RE: LIFT STATION IMPROVEMENTS
WINNER, SOUTH DAKOTA
SPN #14605

ADDENDUM NUMBER 1

The following modifications are to be made to the plans and specifications for the Lift Station Improvements Project.

Sheet Name:
Existing Lift Station Removals

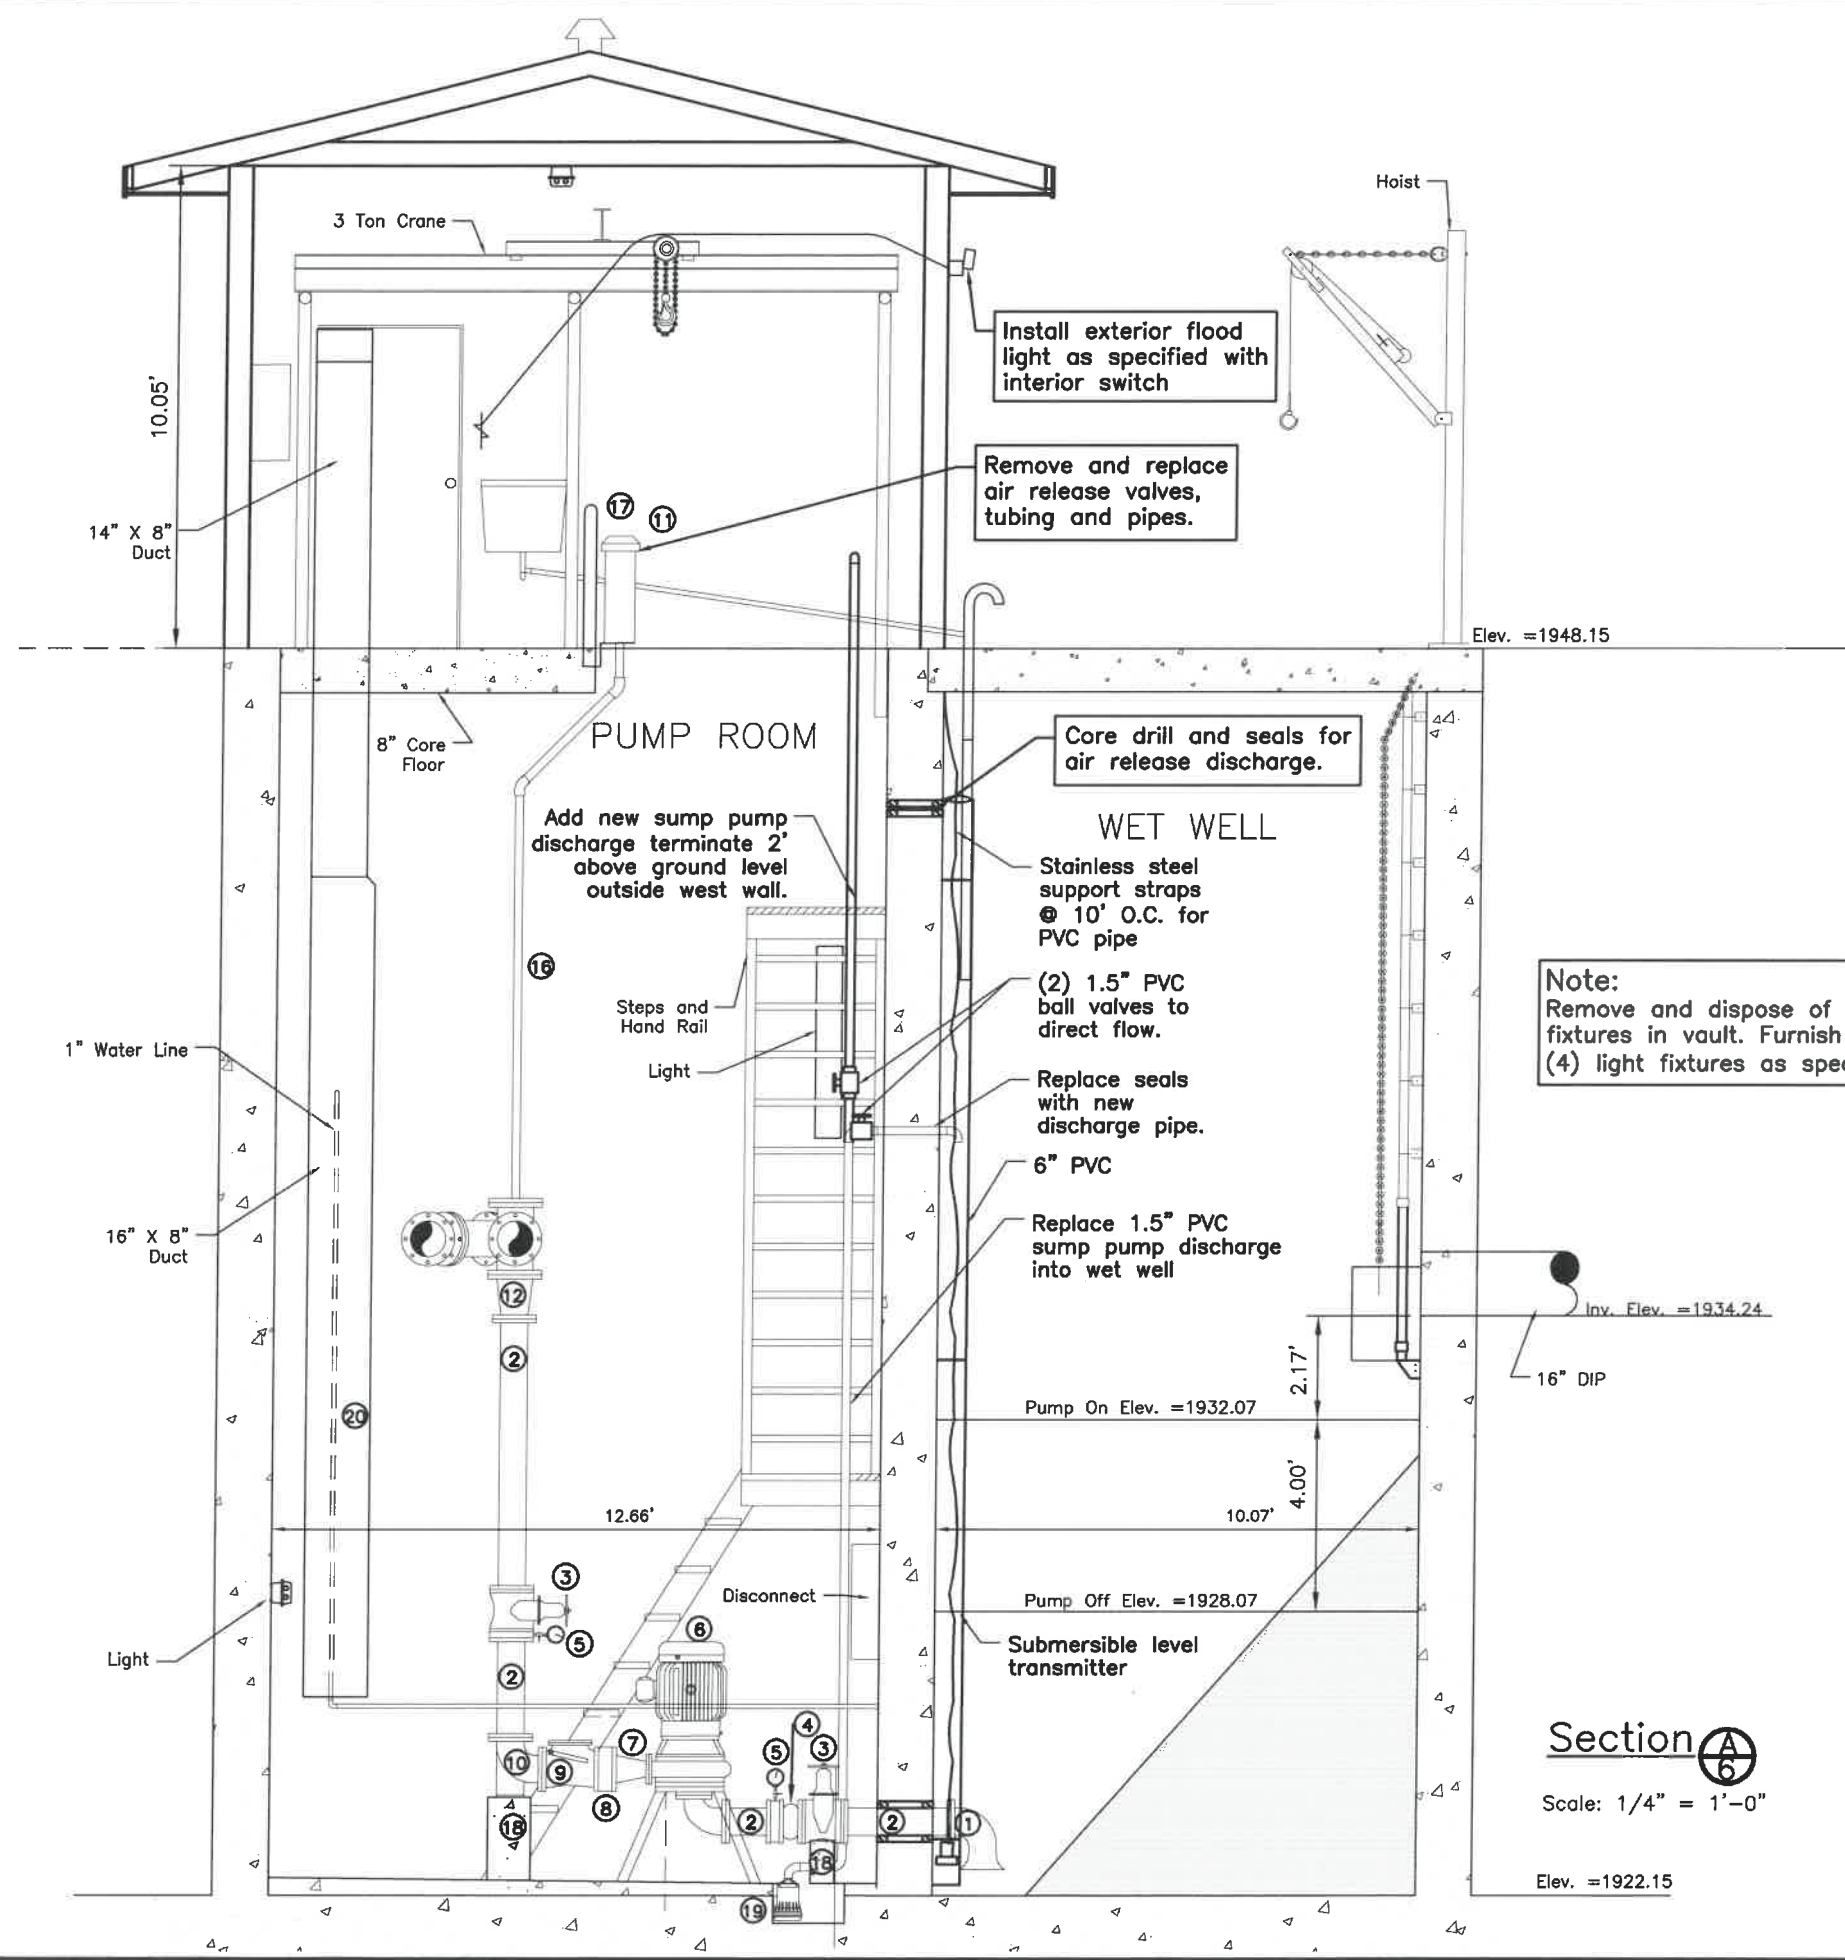
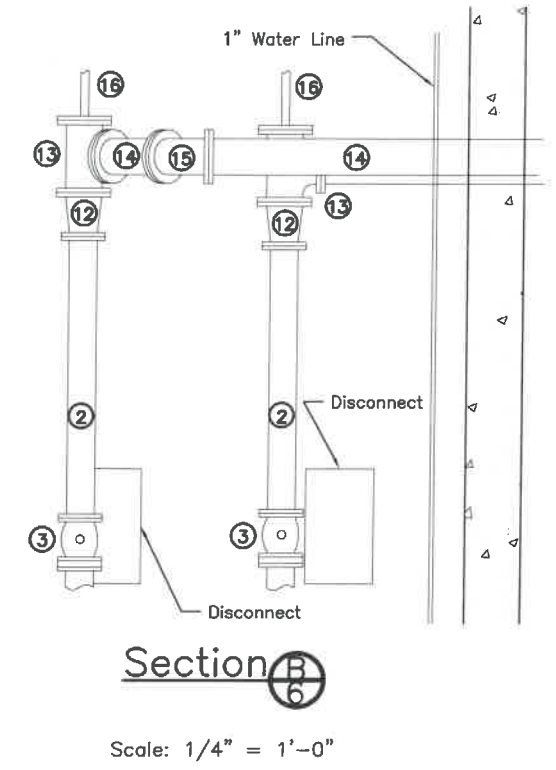
Plan Sheet 6 shall be replaced with the attached plan sheet.

02/15/18	Added sump pump discharge and transducer pipe. Revisions By DJR.
----------	--
